Access Compliance Report

Public Rights-of-Way

(Curb Ramps)

Intersection ID: 17596	Main Street: WATER_OAK_RD	Cross Street: N_SHARON_AMITY_RD	Location: SW
ADA ID: 7DDF4C4474B4	Ramp Type: BlendTrans2	Initial Pass/Fail: Fail	Overall Compliance: No
		Severity Score: 8.75

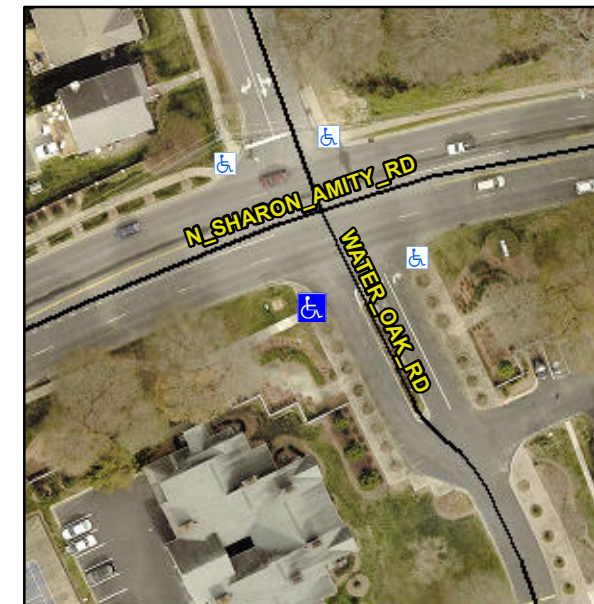
R304.5.1

Possible Solutions:

Remove & Replace Curb Ramp With Two New Directional Ramps or Equivalent.
